**FINAL DECISION**  
**Ergon Energy determination**  
**2015–16 to 2019–20**

**Attachment 6 – Capital**  
**expenditure**

October 2015

**Figure 6.4 Capex per customer (000s, \$2013–14), against customer density**

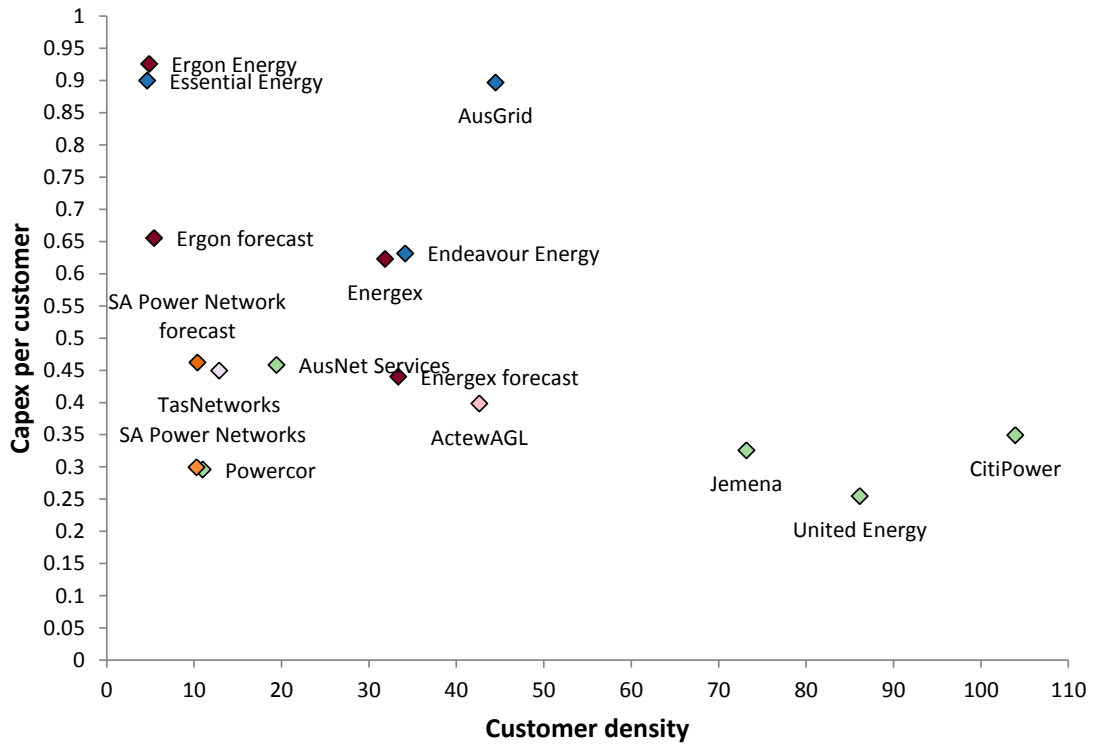
Figure 6.4 shows that Ergon Energy had the highest capex per customer for the 2008–2012 period. Ergon Energy's capex per customer will decrease for the 2015–20 regulatory control period based on their proposed forecast capex. However, even after this reduction Ergon Energy's capex per customer is still among the highest in the NEM.

**Figure 6.5 Capex per maximum demand (000s, \$2013–14), against customer density**

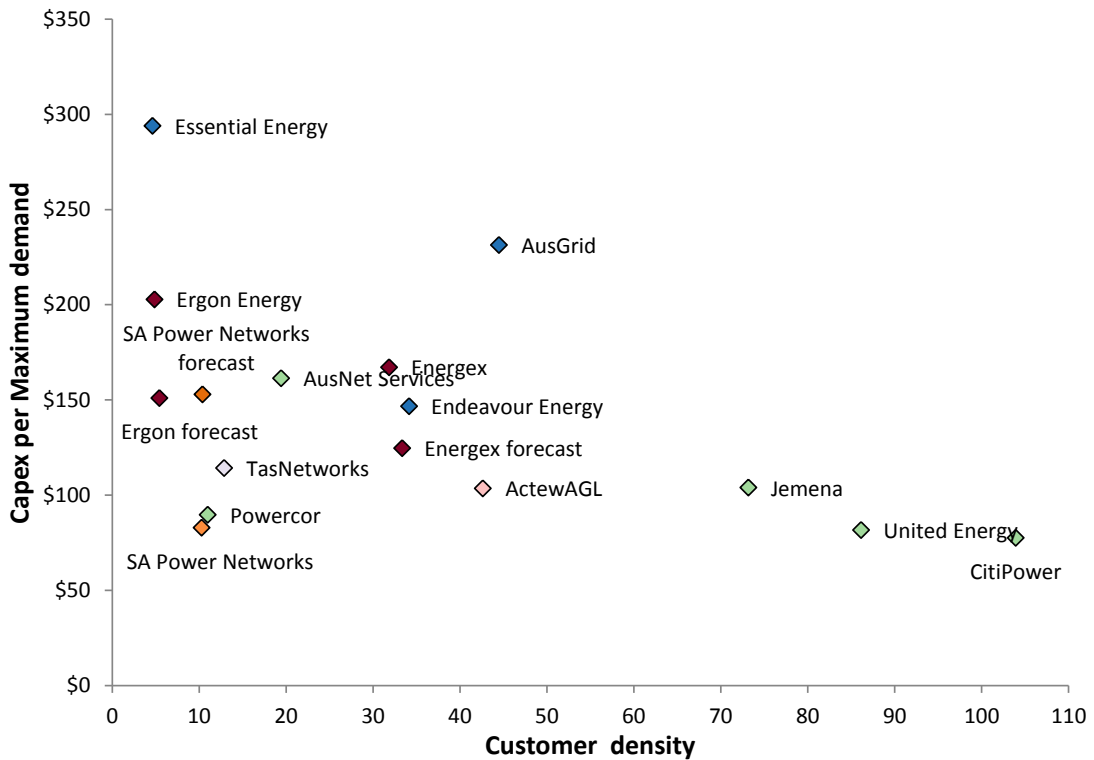
Figure 6.5 shows that Ergon Energy's capex per maximum demand for the 2008–2012 period was among the highest in the NEM. Ergon Energy forecasted capex per maximum demand to decrease in the next period at a level close to the Victorian distributors.

**Figure 6.6 Ergon Energy total capex – historical and forecast 2002–2020**

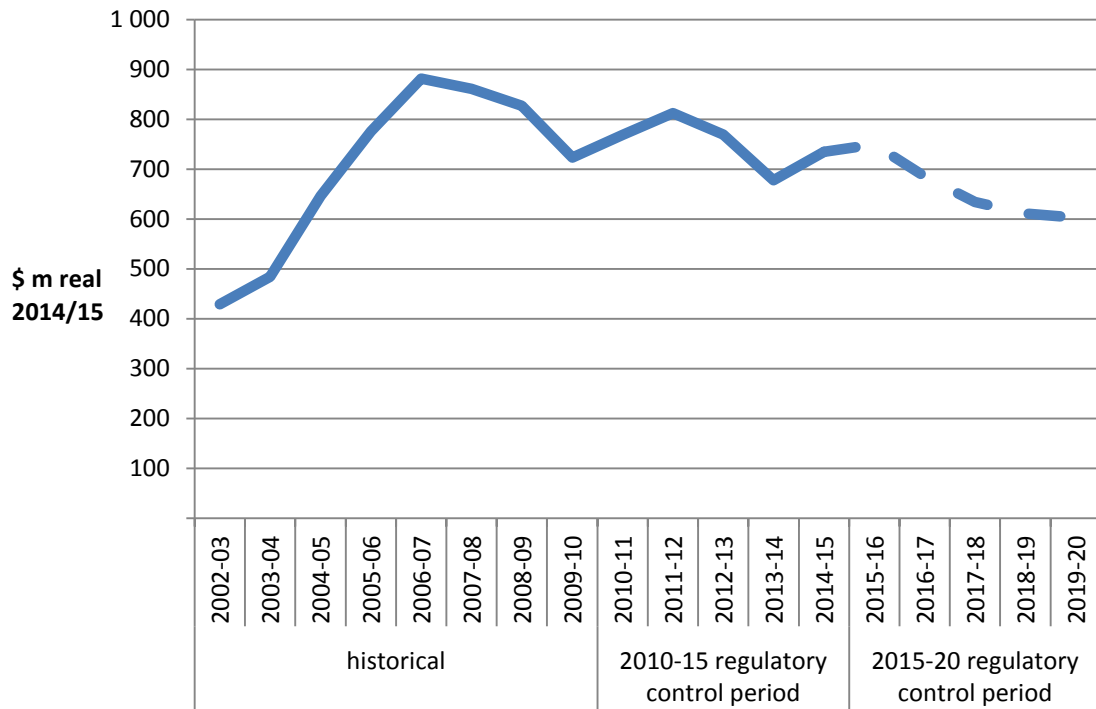
Figure 6.6 shows actual historic capex and proposed capex between 2002–03 and 2019–20. This figure shows that while Ergon Energy’s proposed capex for the 2015–20 regulatory control period is similar to that in the previous regulatory control period, it is also a substantial increase over the expenditure in the early 2000’s.

Submissions received by us noted that the Queensland distributors significantly increased capex expenditure post 2005. This was due to flatter demand prior to 2005 as well as a change in jurisdictional standards in 2006 which drove investment in the networks. Submissions from interested parties suggest that the AER should have regard to the level of capex in 2000 to 2005 when considering proposed capex for the 2015–20 period. Several stakeholders consider this a more like for like comparison.<sup>37</sup>

In considering an approved level of capex we have not only considered past capex trends, rather we have used a range of methods available to us to assess the businesses proposals. We discuss these methods in further detail in the appendices to this attachment.

**Figure 6.7 Zone substation forecast utilisation 2014–15 to 2019–20 (without additional augmentation)**

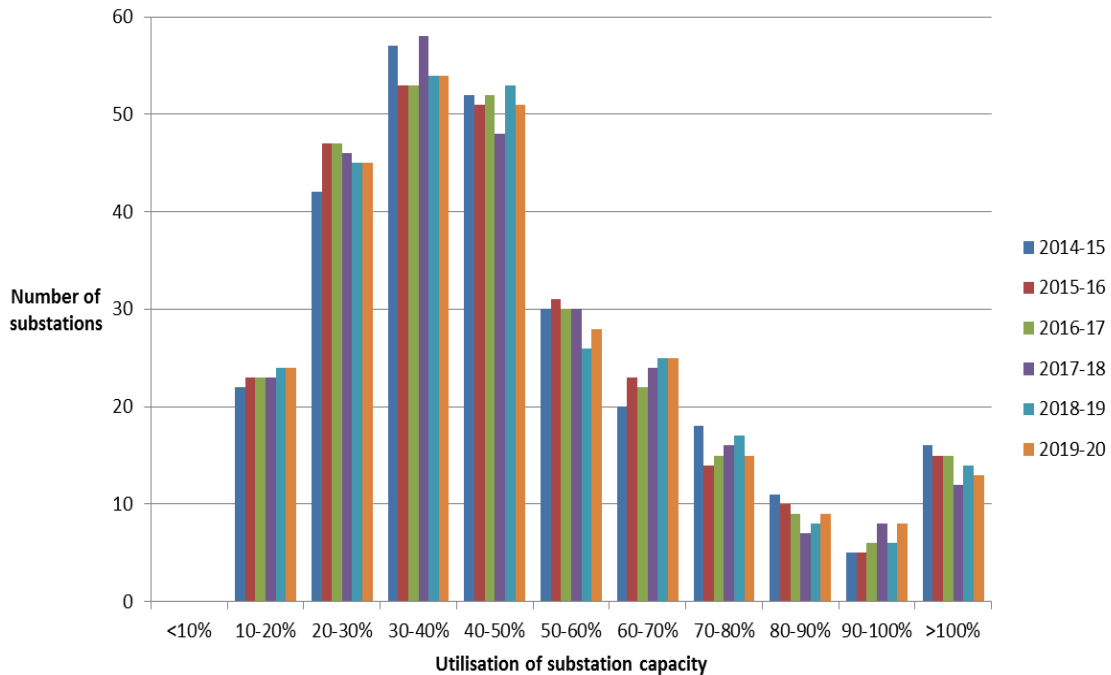
- Ergon Energy's forecast network utilisation at each zone substation shows that the number of highly utilised zone substations is expected to decrease slightly over the 2015–20 period. However, there remain a number of highly utilised substations that Ergon Energy may need to augment over the 2015–20 regulatory control period. This is evident in Figure 6.7 below, which shows that Ergon Energy expects that 20 or more of its zone substations will operate above 90 per cent of its capacity by 2020 (in the absence of augmentation).

For this assessment we looked at forecast network utilization at the zone substation level which gave us an indication of whether there were forecast localised capacity constraints over the 2015–20 period. This is shown in Figure 6.7 above, which shows that several specific zone substations are expected to be highly utilised by the end of

**Figure 6.8 Ergon Energy – Actual and expected repex (\$m 2015–16)**

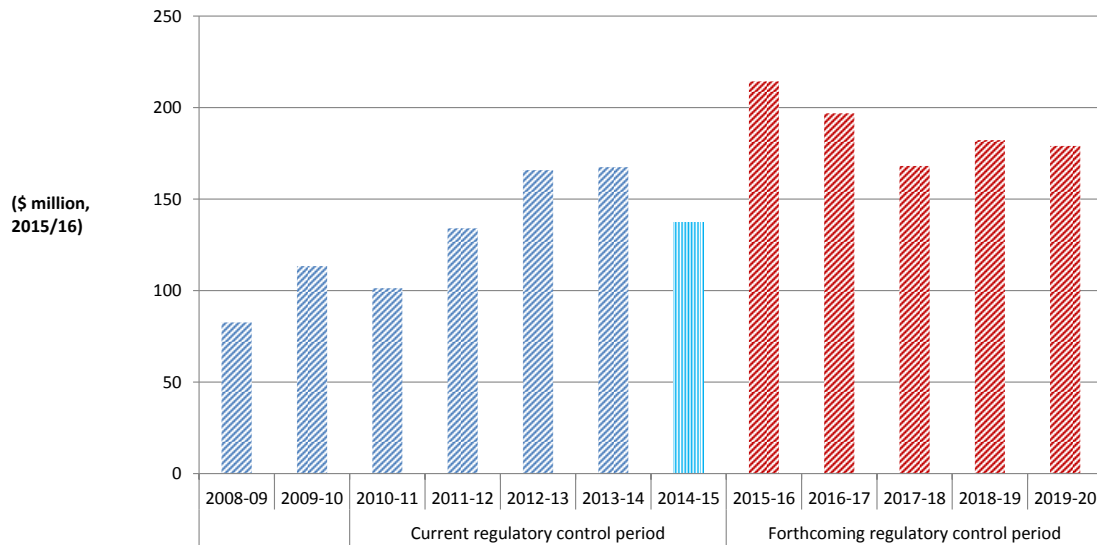
Figure 6.8 shows Ergon Energy's repex spend since the early 2000s is highly variable with its proposal for the 2015–20 regulatory control period well above the long term average repex.

**Figure 6.10 Comparison of AEMO and Ergon Energy’s summated connection point forecasts (MW, non-coincident)**

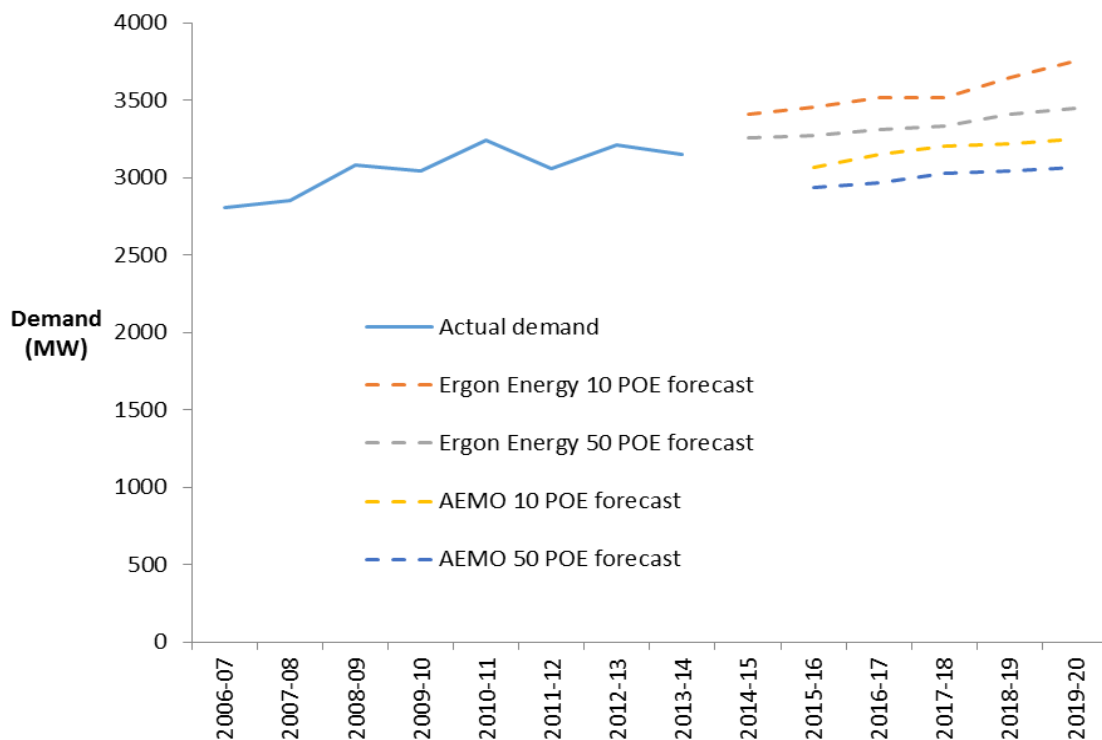
Figure 6.10 shows our comparison between Ergon Energy’s system demand and AEMO’s summated connection point demand for the Ergon Energy’s network. It shows the growth trend for Ergon Energy’s system demand forecast is consistent with AEMO’s connection point forecasts for Ergon Energy’s network for the 2015–20 period. This gives us a level of confidence the trend in Ergon Energy’s forecasts are realistic (although the level of Ergon Energy’s demand forecasts are higher than AEMO’s).
